UNITED STATES PATENT AND TRADEMARK OFFICE

10/542,603

Office Action Summary	Application No. 10/542,603	Applicant(s) KANEMOTO ET AL.	
	Examiner NADER BOLOURCHI	Art Unit 2611

DETAILED ACTION

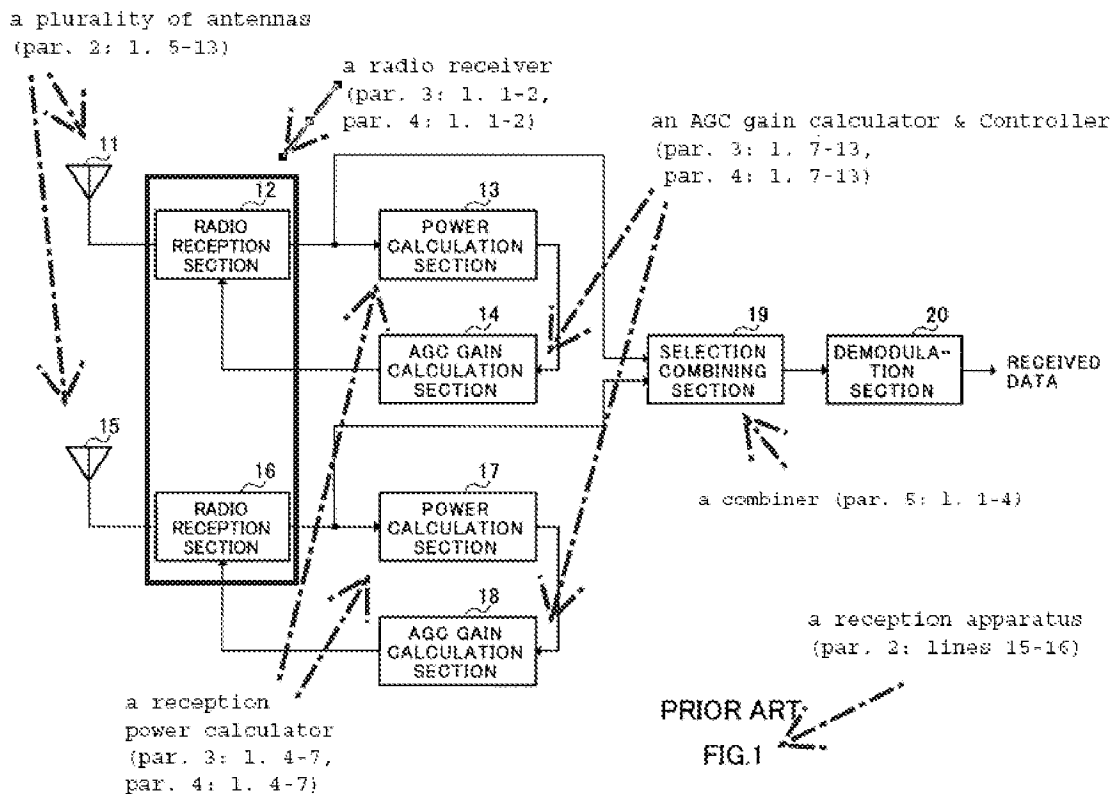
9. Claim 1 is rejected under 35 U.S.C. 102(a) as being anticipated by
Admitted Prior Art ("APA" herein after; Fig. 1 and pars. 1-5)

Regarding claim 1, APA discloses a reception apparatus (Fig. 1) comprising: a plurality of antennas spaced at a predetermined interval or more; a radio receiver that amplifies signals received in the antennas; a reception power calculator that calculates reception power of a signal received in each of the antennas; an AGC gain calculator that calculates a gain such that amplified reception power is a predetermined value to instruct to the radio receiver; a controller that instructs the AGC gain calculator to calculate a gain to amplify a received signal received in some of the antennas, when the reception power calculator calculates reception power of a signal received in another one of the antennas; and a combiner that combines amplified signals received in the antennas, as shown below:

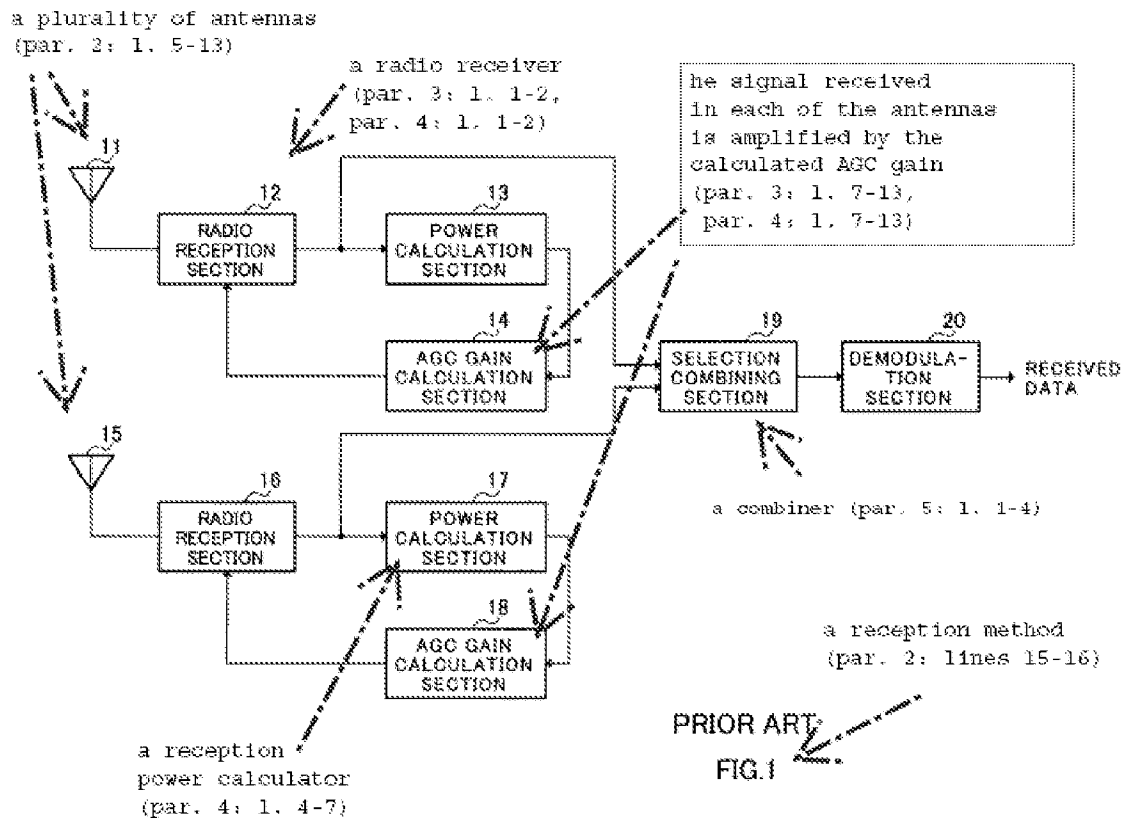
Regarding claim 5, APA discloses a reception method (par. 2: lines 15-16)

wherein radio signals are received in a plurality of antennas (radio signals are input of 11 and 15 in Fig. 1; par. 2: l. 5-13), with respect to the signals received in the plurality of antennas an AGC gain of one of the antennas is calculated (par. 3: lines 7-13) when reception power of the other antenna is calculated (par. 4: lines 1-7), the signal received in each of the antennas is amplified by the calculated AGC gain ("instruction for amplifying" in lines 11-13 of pars. 3 and 4) and , and the signals received in the antennas are selected and combined (Fig. 1: 19; par. 5: l. 1-4).
